Notice of Allowability

10/685,274

SCHMIDT, ALBERT LEO

Marked-up Drawings

FIG. 7

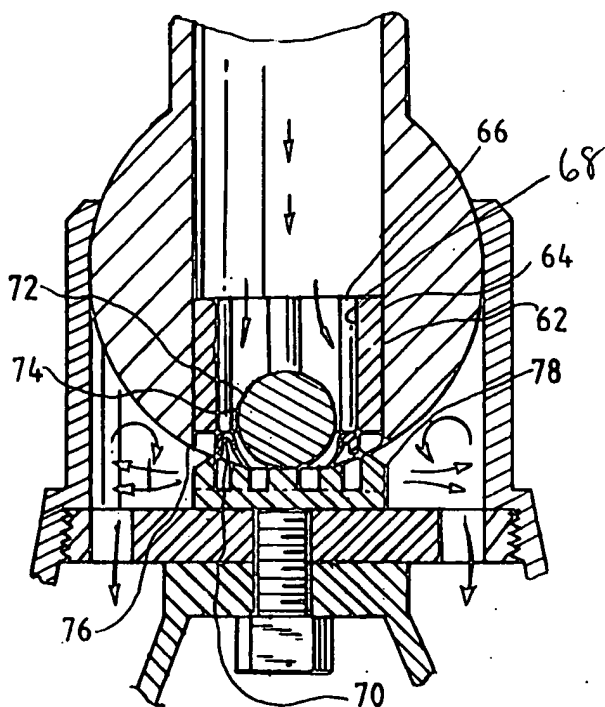
- Figures 7 and 8 must include reference number “68”, which designates the inner circumferential surface of the valve body as disclosed on page 11 of the specification. Please refer to the enclosed marked-up page 3 of 3, which indicates in red ink where reference number “68” should be located in Figures 7 and 8 of Applicant’s Replacement Sheet.
